From: system@acelo.com On Behalf Of [REDACTED]
Sent: Sunday, 15 October 2017 11:14:00 PM (UTC+10:00) Canberra, Melbourne, Sydney
To: [REDACTED]
Subject: Submission Details

Submission for Job: #7485 WestConnex M4-M5 Link

From: system@accelo.com On Behalf Of Holly Gorman
Sent: Sunday, 15 October 2017 11:16:16 PM (UTC+10:00) Canberra, Melbourne, Sydney
[REDACTED]
Subject: Submission Details for Holly Gorman (object)

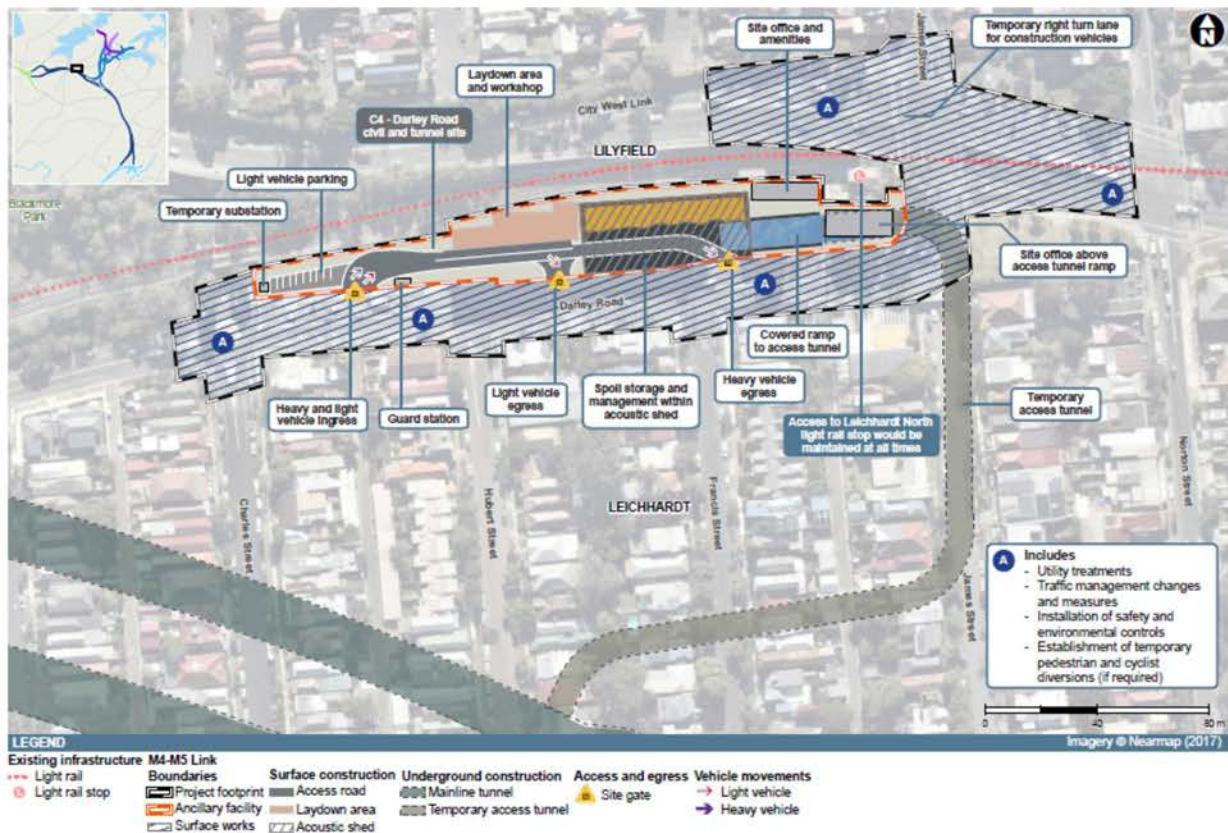
- The proponent has failed to take account of the noise impact of fully laden spoil haulage trucks exiting the Darley Road civil and tunnel site (C4) at Leichhardt driving up the very steep blind turn at the intersection with the City West Link. The RMS should install noise measuring equipment and monitoring cameras at this location to measure noise from heavy vehicles and identify vehicles whose noise that exceeds the applicable Australian standard.

- The proponent has failed to take account of the noise impact of spoil haulage trucks using air brakes on the descent down Darley Rd off the City West Link. Heavy vehicle drivers should avoid using exhaust brakes, engine compression or 'jake' brakes near residential areas and noise-sensitive areas such as hospitals and schools, unless they are necessary for safety reasons. RMS should implement noise limits from engine compression brakes and should use roadside noise 'cameras' as an aid to enforcement as vehicles emitting engine compression brake noise might affect nearby communities.

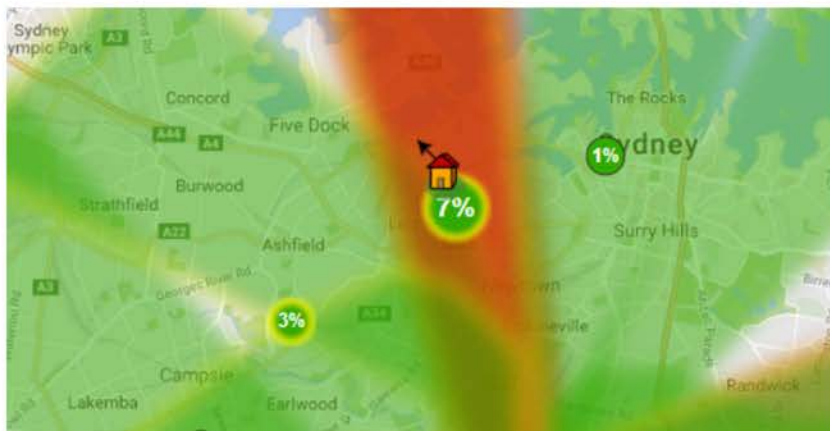
- Use of a rock breaker during the daytime period as part of the demolition works and
- Use of a road profiler during the night-time period as part of the road adjustment works

We object to the EIS because the proponent provides that spoil handling works within the acoustic shed will take place for the duration of the construction phase which could be up to two to three years duration, yet there is no clear plan for measures that will be taken to minimise noise impacts.

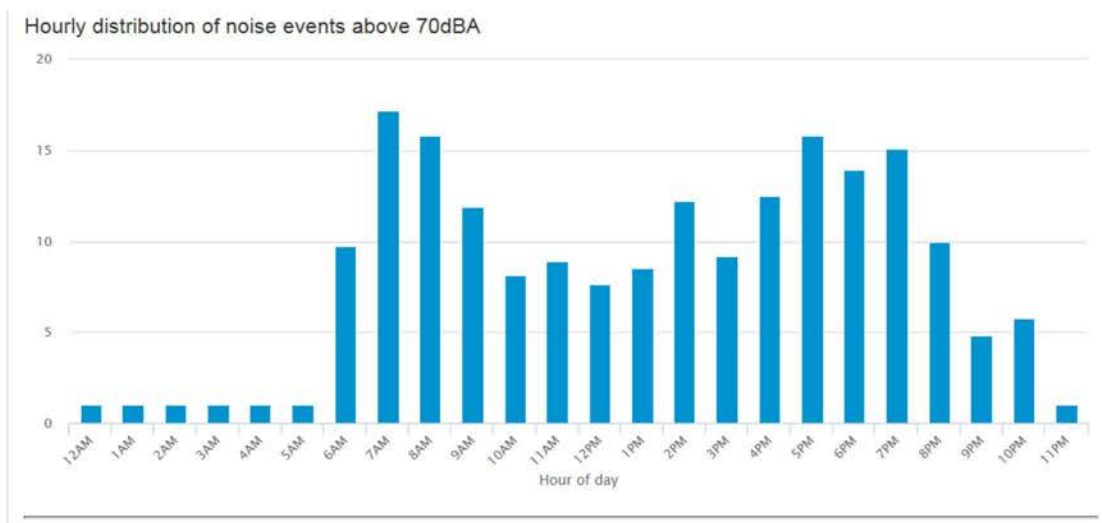
We object to the EIS because the proponent has failed to take account of the cumulative impact of its proposed Darley Road, Leichhardt civil and tunnel site operations and the aircraft noise which the residents near the site already endure. The extract from Webtrak (**below**) shows that Darley Road, Leichhardt and adjacent streets are directly under the flight path.

The above extract from Webtrak shows that Darley Road, Leichhardt and adjacent streets are directly under the flight path.

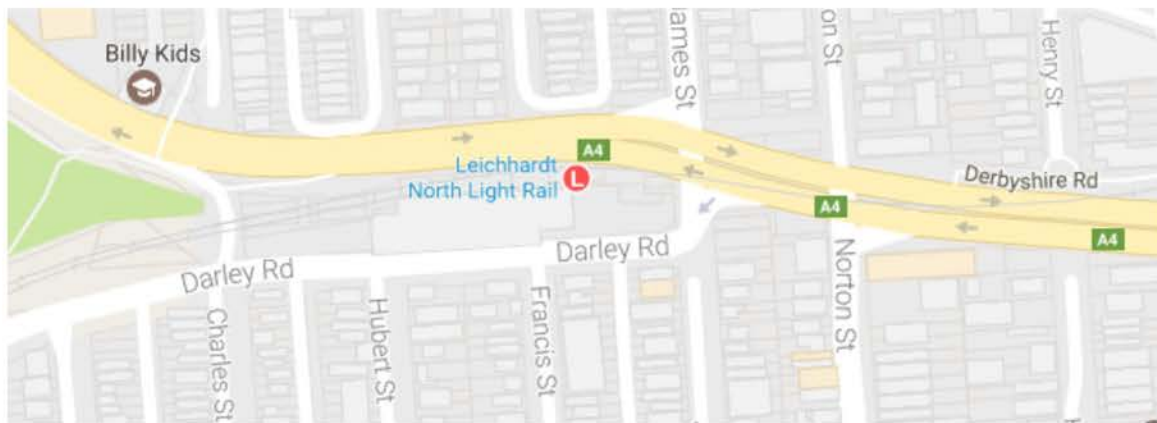
We object to the location of the Darley Road civil and construction site because the site cannot accommodate the projected traffic movements without jeopardising the road network. Darley Road is a critical access road for the residents of Leichhardt and the inner west to access and cross the City West Link. It is already congested at peak hours and the intersection at James Street and the City West Link already has queues at the traffic lights. The only other option for commuters to access the City West Link is to use Norton Street, a two-lane largely commercial strip which is already at capacity. The addition of hundreds of trucks and contractor vehicles will result in traffic grinding to a halt and traffic chaos at this critical juncture with commuter travel times drastically increased.

See image **below** which depicts the location of Darley Road and Norton Street relative to the City West Link:

I object to the whole of the WestConnex Project, and the specific WestConnex M4-M5 Link proposals as contained in the EIS application, for the following reasons:

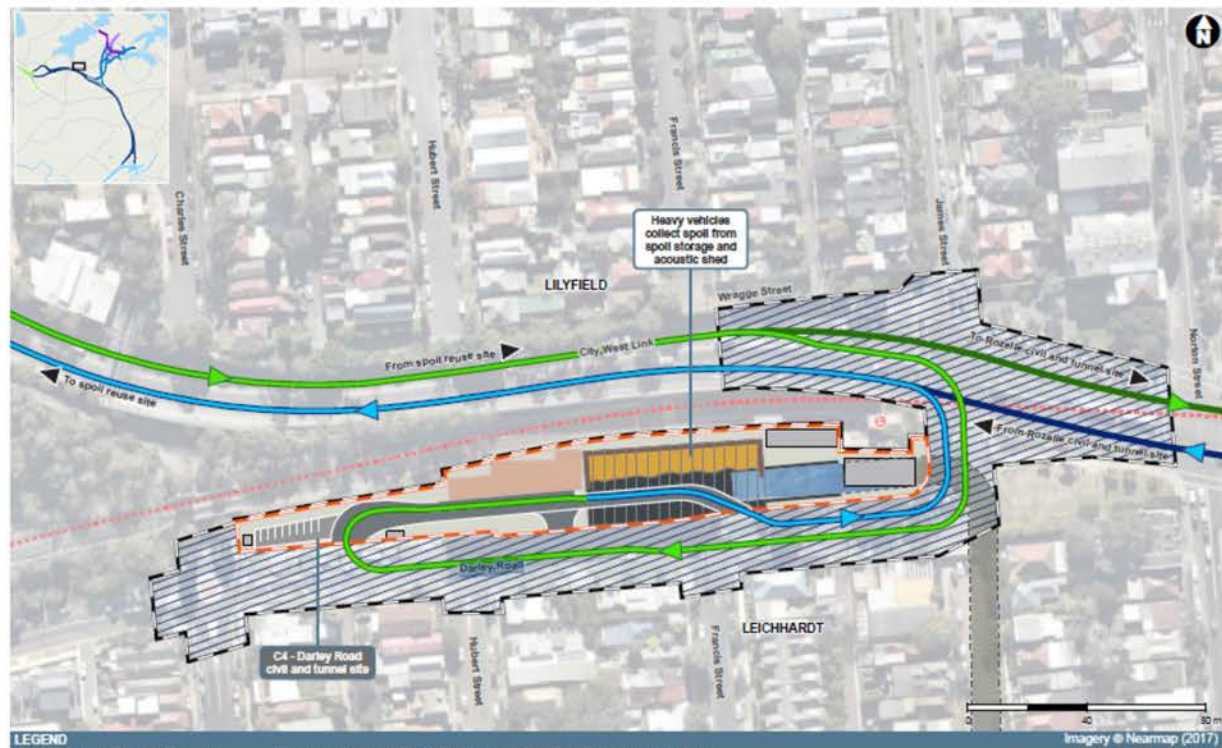
The EIS states that a Construction traffic and Access Management plan (CTAMP) would be prepared to minimise delays and disruptions and identify changes to ensure road safety. The plans are not in the EIS so residents cannot comment. What guarantee is there that the plan will be effective? The EIS should be rejected on the basis that the impacts on traffic and safety are not adequately addressed. It is also inadequate to simply refer to a plan, with no provision for residents and other key stakeholders to be involved in its development and no assurance it can work.
